**Draft Final Conceptual Site  
Model for the  
Yerington Mine Site**

**August 26, 2002**

**Subject: Draft Final Conceptual Site Model and Response to Comments on the  
Draft Conceptual Site Model dated June 13, 2002**

**Figure 1**  
**Yerington Mine**  
**Conceptual Site Model**  
**Flow Diagram**

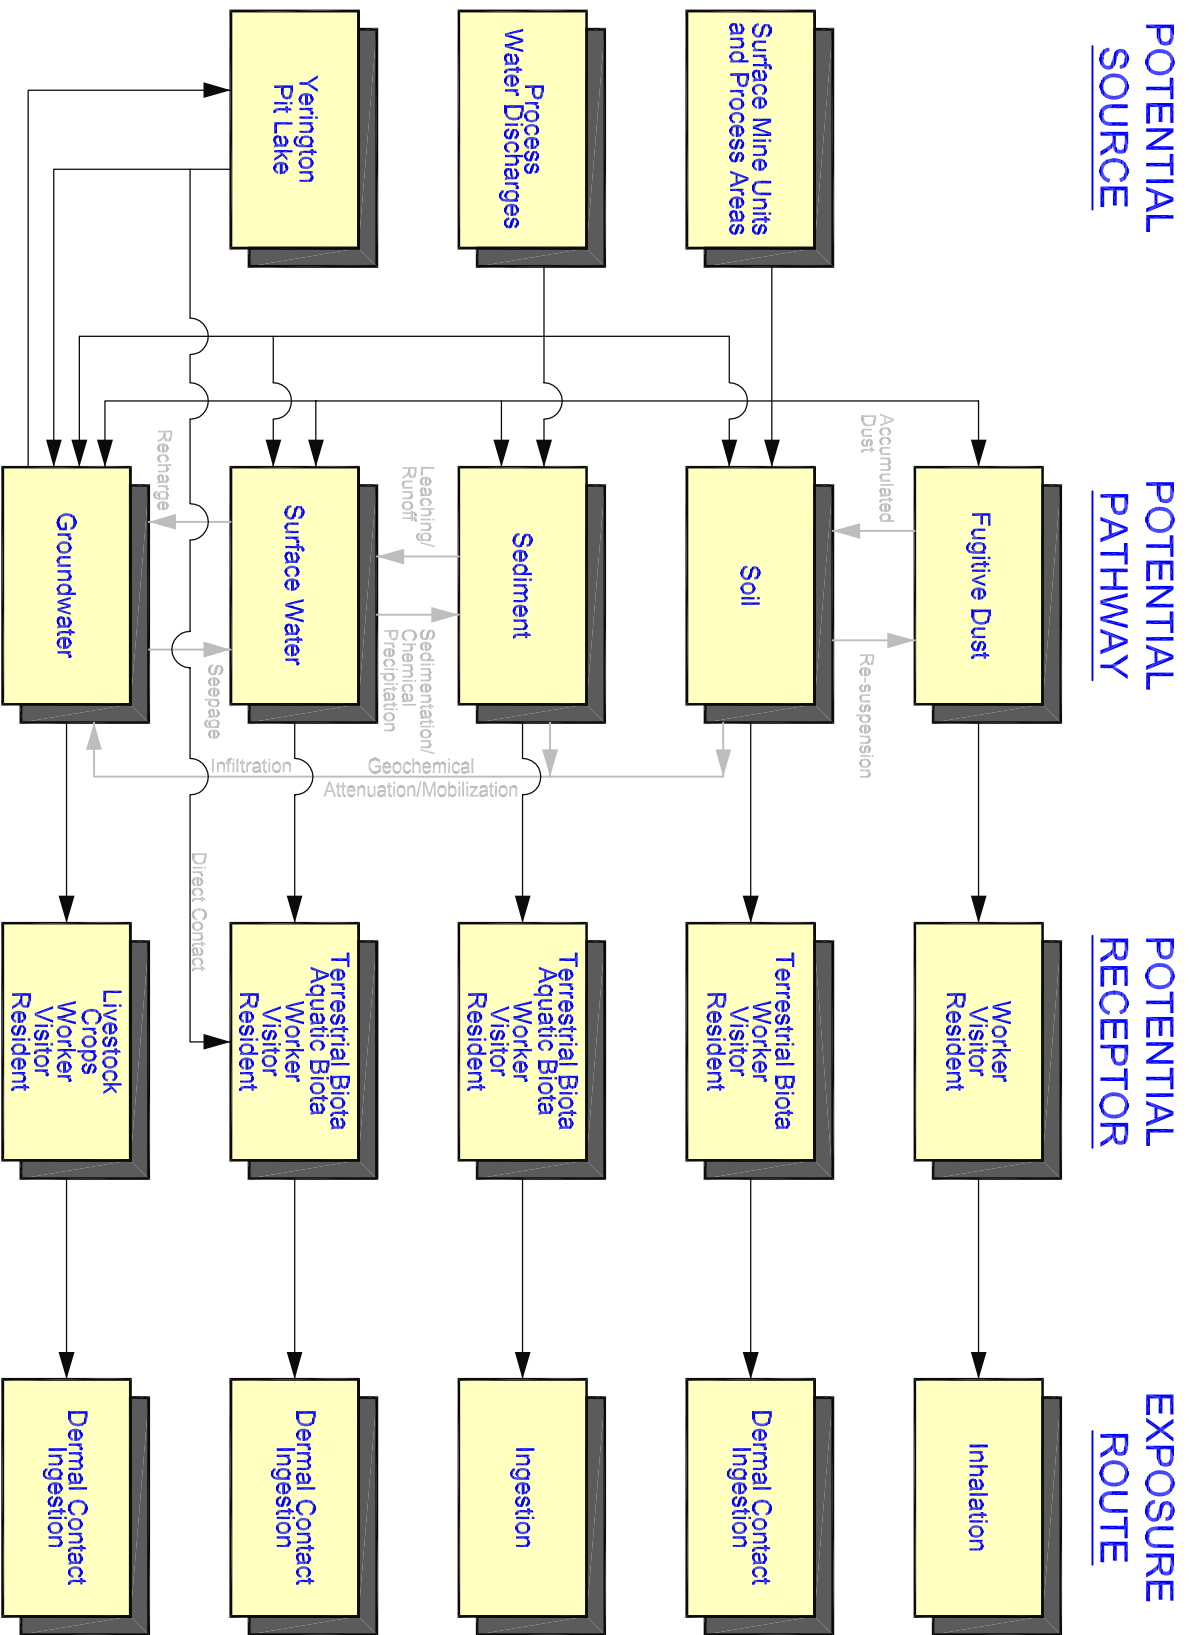
Comment no. 11: Change “Water (Wabuska Drain)” to “Surface Water”. Draw an arrow from Sediment to Surface Water, as surface waters may remobilize contaminants from sediments. Add Terrestrial Biota as a potential receptor from Fugitive Dust. It also seems that there may be dermal contact and incidental ingestion (Exposure Routes) from Fugitive Dust, although minor, as well as dermal contact with sediment.

Some of the specific ecological receptors include livestock (horses) and crops. Dermal exposure route should be added for sediment for human receptors.

An arrow should be drawn from Groundwater to the Yerington Pit Lake.

Please add a key to the chart, showing, at a minimum, the purpose of the black, dotted and blue lines.

For Groundwater: Potential Receptors include livestock and crops. Exposure Route should include dermal contact.

Food chain pathways should be listed on the figure. For example, fish or hunting of game (deer/rabbit).

Add a box in the Potential Sources column for secondary sources to account for a) dust re-suspended and b) sediments to the Wabuska Drain (contaminants to surface or groundwater).

*Response to Comment no. 11: The recommended changes will be implemented. However, the portrayal of food chain pathways is beyond the intent of what the figure is attempting to clarify. Also, the request to add a box in the Potential Sources column for secondary sources to account for a) dust re-suspended and b) sediments to the Wabuska Drain (contaminants to surface or groundwater) will be depicted on the diagram in a different manner than suggested, but should satisfy the intent of the request.*

Figure 2

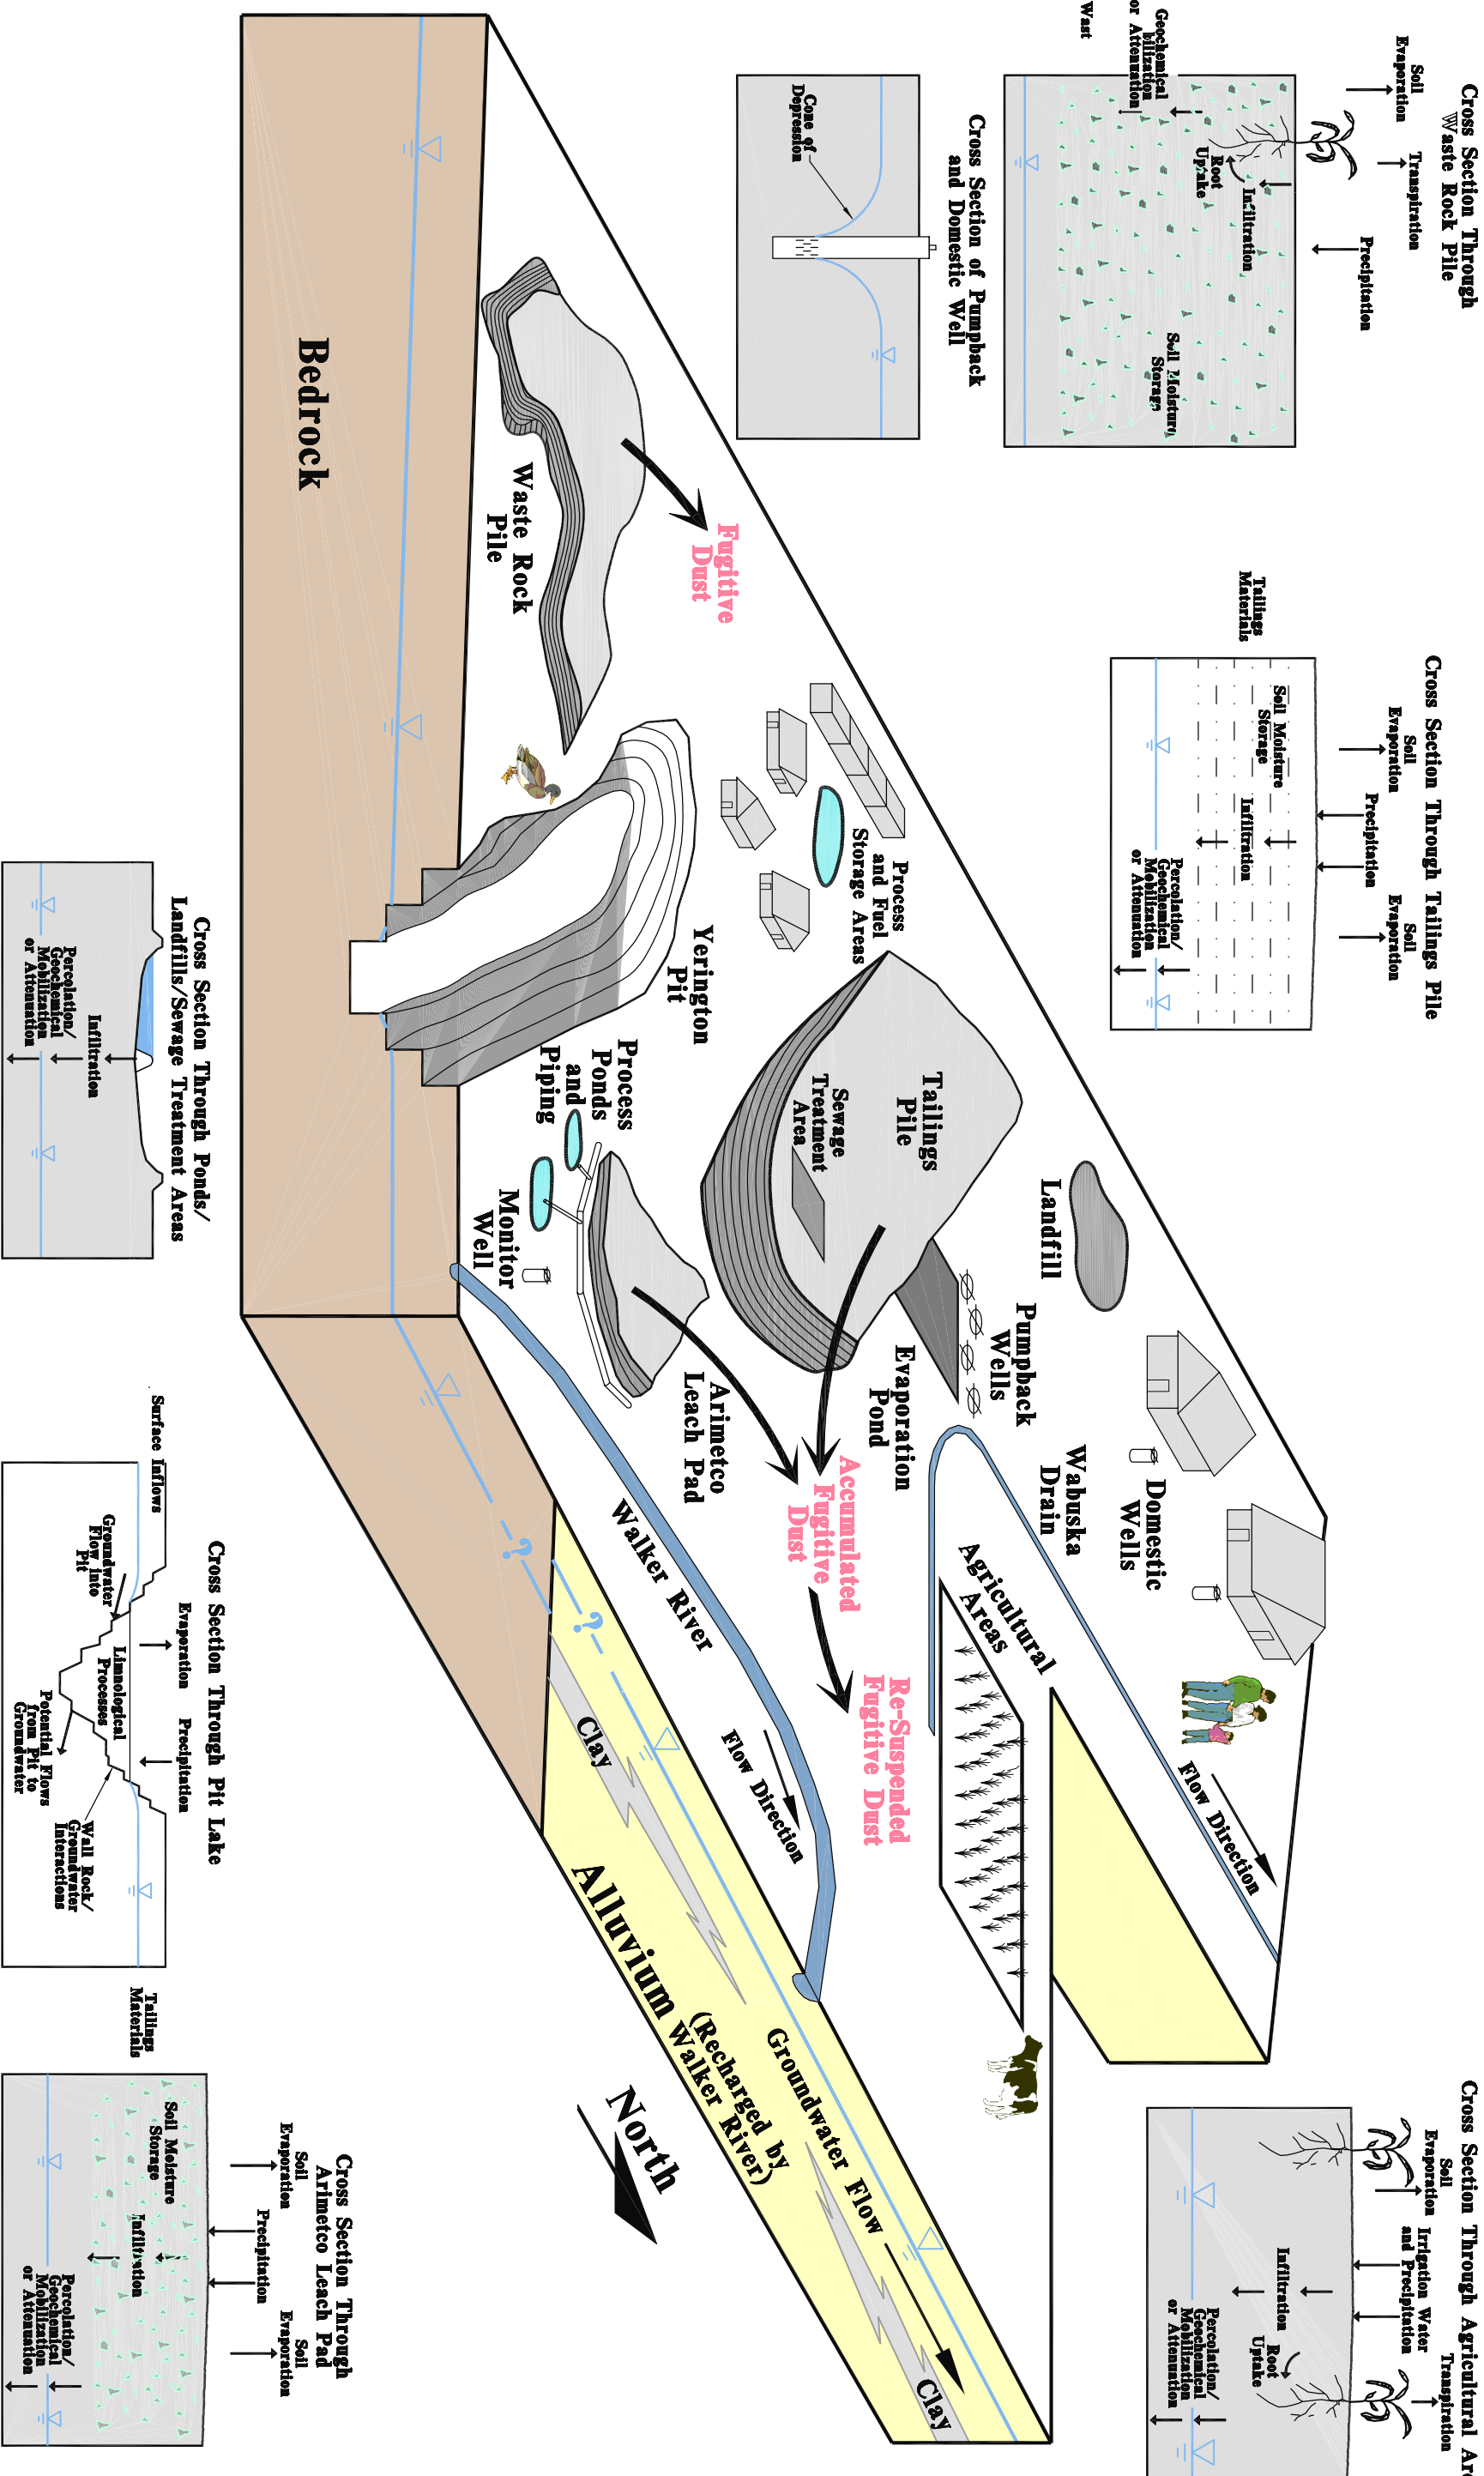
Comment no. 12: Show the direction of flow of the Walker River and also Wabuska Drain. The linkage between Wabuska Drain and the Walker River should be shown. Humans are illustrated as receptors, therefore it would not be inappropriate to put a duck, as a representative species, on the pit lake. The cross section through the tailings pile should also apply to the leach pad. Landfill units should be added to the figure, as well as monitoring wells.

Please add a key for the figure.

The pump back well diagram shows an ideal cone of depression, which is not realistic or actual. The pump back system may not be an effective barrier to impacted groundwater and the drawing should demonstrate that some contaminated or mine impacted groundwater is passing through the line of wells. Ponds with poor, ineffective liners (asphalt) reside down gradient of the pump back wells. This should also be shown.

Ground water could be a potential secondary source of contamination to the pit lake and the pit lake could be a source of contamination to groundwater and/or the Walker river. Add alluvial fan type deposition on Western side of site. This deposition could range from large boulders to fine grained sediments.

Show surface down gradient trends to be north.

At least three types of landfills exist, (municipal waste, flood debris, mine process and equipment waste/debris) these should be shown on the diagram and investigated as potential contaminant source areas. Add sewer treatment ponds as potential sources of ground water impacts.

The Transite Pipe may be source of asbestos that needs to be shown on the diagram.

As mentioned above, there is indication that other unlined ditches and drains may also be potential sources and should be demonstrated on the figure. Historical riverbed channels may be beneath the site and may act as conduits for contaminated groundwater transport. This should also be shown.

Fugitive dust should be depicted as a potential secondary source.

The Pit Lake also should be shown as a potential source to groundwater.

There are other potential areas of surface soil contamination that should be depicted on the figure. For example, areas near the process areas where there are stains. Other features like the electrowinning facility and the transformer recycling operations should be shown on the figure. Currently we assume that they would be included within the Process Areas. Maybe add text to this title to include these other potential sources. Same comment applies to the small "jumpout" map entitled Cross Section Through Arimetco Leach Pad. Possibly make the title more generic to include other potential sources.

Please show connection between Wabuska Drain and the Walker River (possibly an arrow). Also, there is a potential for terrestrial and aquatic biological receptors impacted by groundwater discharges to irrigation ditches and the Walker River (depending on groundwater surface water interactions in the vicinity of the Site).

Include livestock in the agricultural areas.

*Response to Comment no. 12: The revised figure will show the direction of flow of the Walker River and also Wabuska Drain. Given the intent of the schematic, it will not be possible to actually show the confluence of the Wabuska Drain and the Walker River, but an arrow could work. A duck on the pit lake has been added as a representative species. We agree that the cross sections could be applicable to more than one type of surface mine unit, and will attempt to consolidate these sections. Landfill units and monitoring wells will be added to the figure*

*A key for this type of figure is not useful. The text will be expanded to better describe the information presented in the figure.*

*The block diagram is intended to schematically represent potential site sources, pathways and receptors. No one is certain of the drawdown cone geometry associated with a pumpback system well, and since the wells are completed in an alluvial aquifer, the "ideal" cone shape is appropriate for the conceptual diagram. Whether or not the pumpback system is an effective barrier to groundwater flow from the mine site is yet to be determined through the implementation of the Groundwater Conditions Work Plan. The ideal cone of depression in this schematic block diagram does not imply anything about the effectiveness of the pumpback system. Again, the schematic is attempting to depict process, evaporation and tailings ponds, in general, as potential sources. Specific details such as the description and evaluation of ponds with possible poor, ineffective liners should be left to the specific Work Plans.*

*For this schematic diagram, the specifics regarding the hydraulic connection between groundwater flow in alluvial and bedrock flow systems, the Yerington Pit Lake and the Walker River may be difficult to depict. Atlantic Richfield will attempt to provide more of these details on the diagram without overcrowding the figure. However, if these details are incorporated, other details would be left out, creating a schematic diagram that is inconsistent. These details, and alluvial fan depositional environments will be discussed in the revised CSM text. Also, these details will be discussed at length in the Groundwater Conditions Work Plan and depicted graphically.*

*The figure has been modified to “Show surface down gradient trends to be north”, and to the east as these are the general topographic trends at the site.*

*The revised figure will include a generic landfill and a generic sewage treatment pond as potential sources of groundwater impacts.*

*Transite pipe may be source of asbestos, but that is too detailed for the intent of the schematic. A generic pipeline has been added to the schematic. Text describing transite pipe as a possible source has also been added to the CSM.*

*Please see Response to Comment no. 1. As far as detailed hydrogeologic information is concerned, such as historical riverbed channels beneath the site, this level is too detailed for the schematic and is best addressed in the Groundwater Conditions Work Plan, which presents a conceptual hydrogeologic model.*

*Fugitive dust will be depicted as a potential secondary source on the schematic.*

*The Pit Lake will be shown as a potential source to groundwater.*

*Atlantic Richfield attempted to present generic sources on the schematic, including potential areas of surface soil contamination and the electro-winning plant under the general depiction of Process Areas. Former transformer recycling operations are best presented in the more specific Process Areas Work Plan. As appropriate, the revised figure will present an idealized cross section for more than one type of surface mine unit (e.g., combine leach pad with waste rock pile).*

*Please see the first paragraph under this response regarding how best to represent the connection between the Wabuska Drain and the Walker River. The discussion of potential groundwater discharges to irrigation ditches and the Walker River is too detailed for the CSM, but will be addressed in the Groundwater Conditions Work Plan.*

*A picture of a cow is included in the agricultural area.*
